# Access Compliance Report

## Public Rights-of-Way

Intersection ID: N/A	Main Street: BALLANTYNE CORPORATE PCross Street: N/A	Location: NW
ADA ID: 30A00B790FBD	Ramp Type: Directional1	Initial Pass/Fail: Fail
	Overall Compliance: No	Severity Score: 13.75
Codes/Mitigation Info/Possible Solution		Field Measurements/Component Compliance

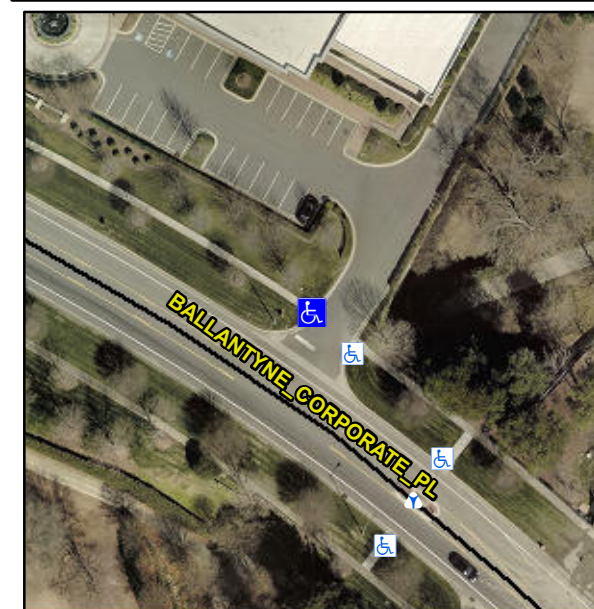
**R304.2.2, R304.5.3**

Compliance	Description	Data	Compliance	Description	Data
N/A	Ramp Length (in)	78.0	N/A	Grade Break?	N/A
Yes	Ramp Width (in)	48.0	N/A	Grade Break Slope (%)	0.0
No	Ramp Slope (%)	8.8	N/A	Grade Break XSlope (%)	0.0
No	Ramp XSlope (%)	2.3			
N/A	Flare Type LT	N/A	N/A	Flare Type RT	N/A
N/A	Flare Slope LT (%)	N/A	N/A	Flare Slope RT (%)	0.0
N/A	Flare Traversable LT?	N/A	N/A	Flare Traversable RT?	N/A
N/A	Landing Length (in)	0.0	N/A	DWS Provided?	N/A
N/A	Landing Width (in)	0.0	N/A	DWS Contrast?	N/A
N/A	Landing Slope (%)	0.0	N/A	DWS Length (in)	N/A
N/A	Landing X Slope (%)	0.0	N/A	DWS Full Width?	N/A
N/A	Landing Curb? (Y/N)	N/A	N/A	DWS Offset LT (in)	N/A
N/A	Shared Landing?	N/A	N/A	DWS Offset RT (in)	N/A
N/A	Gutter Ponding?	0.0	N/A	Gutter Slope (%)	N/A
N/A	Gutter Lip Ht (in)	0.0	N/A	Gutter X Slope (%)	N/A
N/A	Painted X Walk1?	No		Road Slope (%)	2.6
	X Walk 1 Direction	To SE		Road X Slope (%)	2.8
	X Walk 1 Width (in)	N/A		Clear Space?	N/A

**Remove & Replace Entire Ramp.**
